Quality Marine, Inc. VMI Series 200 Constant Voltage Battery Charger

Addendum

Please include these changes to page 10 of the Owners Manual.

Equalize Timer DIP Switch Settings

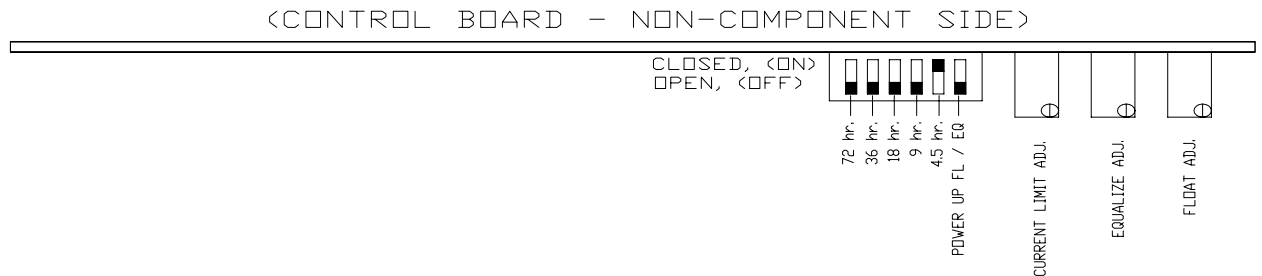
The timer duration is adjustable from 4 ½ - 139 ½ hours in 4 ½ hour steps. The adjustment for timer duration is located inside the charger next to the voltage controls. *See Section 6, Operation and Initial Settings and fig. 7-1.* The switch settings may be combined in any order to produce a combination of the values (they are additive).

The Equalize mode may be disabled by setting all switches to open (off).

The Voltage Minimum Adjustment Pot has been eliminated. (See illustration above)
